DEVELOPMENT APPLICATION

PDPLANPMTD-2026/058902

PROPOSAL: Signage, Seven warehouses (Storage) and Car Rental Facility (Transport Depot and Distribution)

FURTHER INFORMATION REQUEST - PLANNING APPLICATION - PDPLANPMTD-2026/058902 - 32 KENNEDY DRIVE, CAMBRIDGE WITH ACCESS FROM MCRORIE COURT

1:100

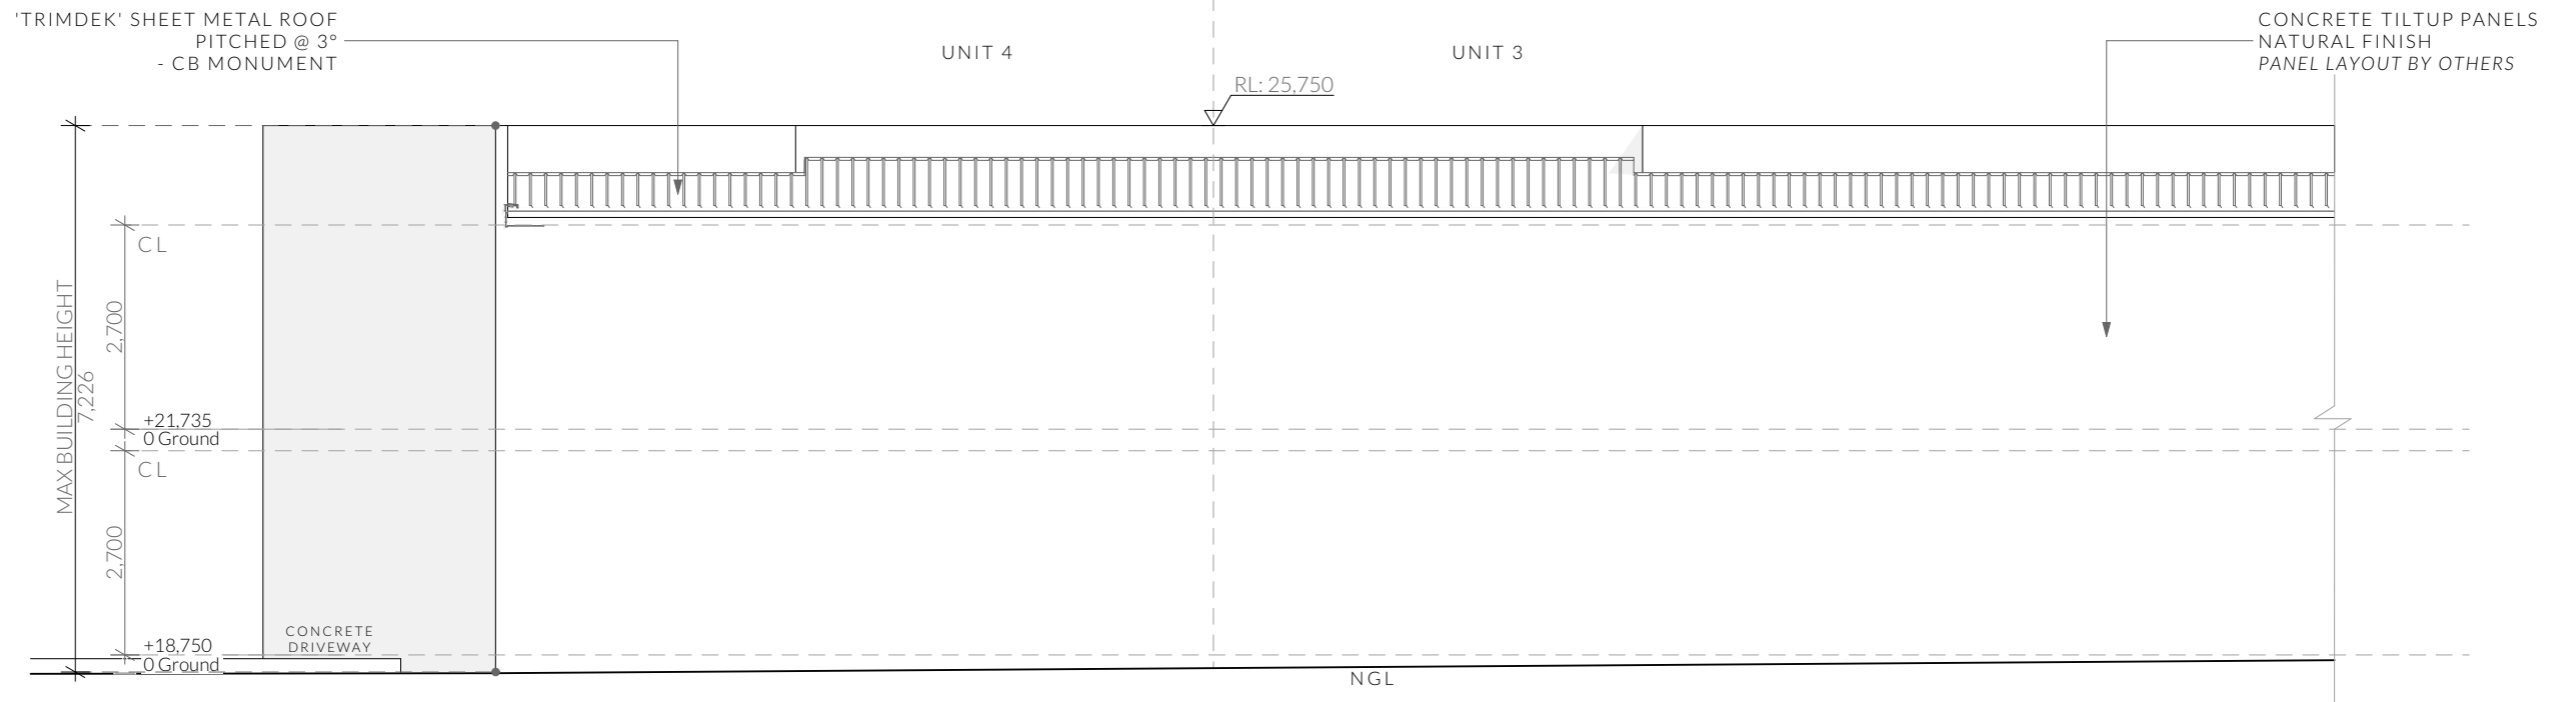
Clause 18.4.1 A1 Building height - Revised elevation plans detailing the maximum height of each tenancy in relation to modified and existing ground level.

Response: Updated plans are provided (Attachment 2) that show that the maximum height of each tenancy complies with 18.4.1 A1 which requires building height to be not more than 10m.
